EXHIBIT A:
STATION CONCEPTS

Subject: SCH#2010051001: Comments to Mid-Coast Corridor Transit Project

SUBJECT: SCH# 2010051001; **Mid-Coast Corridor Transit Project** Draft SEIS/SEIR

Subject: At-Grade Pedestrian-Rail Crossings in Transit Stations on Mid-Coast Project

Figure 1-18. Site Concepts for Executive Drive Station, with and without Genesee Avenue Design Option

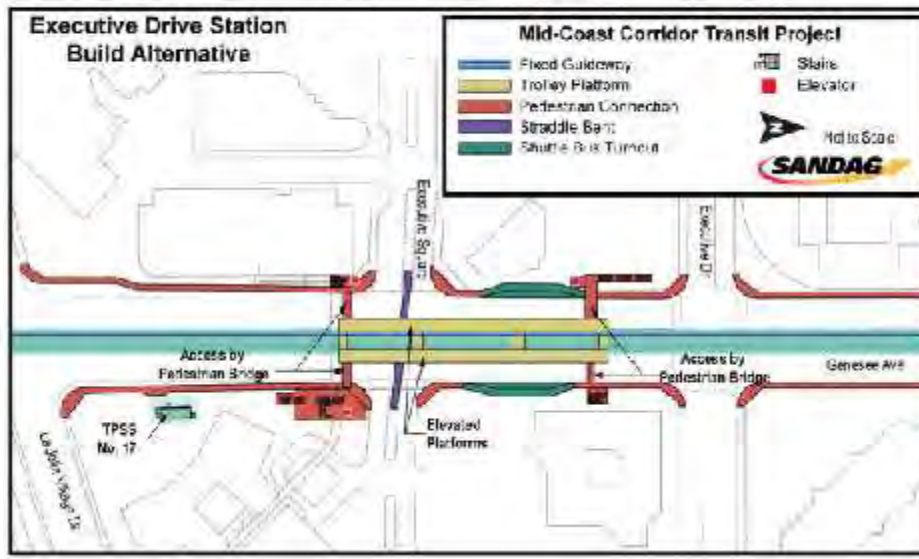
1. **Open-platform stations:** CPUC staff is concerned with and opposes the proposed station designs along the new alignment. Although this station design is employed elsewhere throughout the San Diego Trolley system, the design introduces some hazards that could be eliminated through alternative designs. The station design allows pedestrians to cross the tracks within the station at any point along the

platform without the benefit of warning devices. Sight distance between a pedestrian and an approaching light rail vehicle is frequently limited by another light rail vehicle already stopped at the station, curves on the approaches, pedestrian distractions and other factors. We recommend that SANDAG's Hazard Analysis Report analyze this hazard, potentially including a review of past collisions between light rail vehicles and pedestrians at SDTI stations. There will need to be further discussion of the maximum allowed operating speeds at these locations between CPUC Staff, SANDAG and SDTI.

We recommend SANDAG revise its proposed open-platform station design to address limited pedestrian visibility and the lack of designated pedestrian crossings, and incorporate mitigation measures to address the hazard of collisions between light rail vehicles and pedestrians.

Com ID	Response
1	The CPUC's jurisdiction has been noted. The CPUC's jurisdiction is identified in Chapter 2.0, Section 2.2.2 of the <i>Mid-Coast Corridor Transit Project Safety and Security Impacts Technical Report</i> .
2	SANDAG will develop a Safety and Security Certification Plan during design for approval by the CPUC.
3	The eight existing grade crossings from Santa Fe Depot to the San Diego River are not being reconstructed or altered at the crossing by the project and will not require a CPUC General Order 88-B application. SANDAG will submit a CPUC Form G "Report of Completed Changes at Rail Crossing" to report completion of signaling control revisions at each of the eight existing crossings from Santa Fe Depot to the San Diego River. A formal application will be submitted for new grade-separated crossings at: Friars Road, Tecolote Road, Clairemont Drive, Garnet Avenue, State Route 52 interchange ramps, La Jolla Colony Drive, I-5 south of Nobel Drive, Nobel Drive, La Jolla Village Drive and I-5 access ramps, Gilman Drive east of the VA Medical Center, Artists Lane, Lyman Avenue, two crossings of Voigt Drive, I-5 alongside Voigt Drive, Campus Point Drive, Genesee Avenue, Eastgate Mall, Executive Drive, and La Jolla Village Drive. Formal applications will be submitted for two pedestrian grade crossings: one at the Executive Drive Station and one at the UTC Transit Center.

8	<p>Refer to the response to Comment 7 regarding pedestrian crossings at platforms. At the Executive Drive Station and the UTC Transit Center, automatic flashing lights and audible warning devices will be provided because the general public will use the platforms to cross over Genesee Avenue. The San Diego LRT design standards do not require fencing between the tracks in stations; refer to the response to Comment 10 for additional information regarding fencing at stations.</p>
9	<p>San Diego Trolley light rail vehicles have horns with sound levels that can be heard by patrons and pedestrians above ambient station noise. Federal and state requirements are currently met on the existing system, and the same requirements will apply to stations along the project alignment. Sound screening as required will be provided at stations near I-5 (the Nobel Drive and VA Medical Center Stations) to reduce ambient noise if the levels are above a level that would reduce the effectiveness of the train horns.</p>
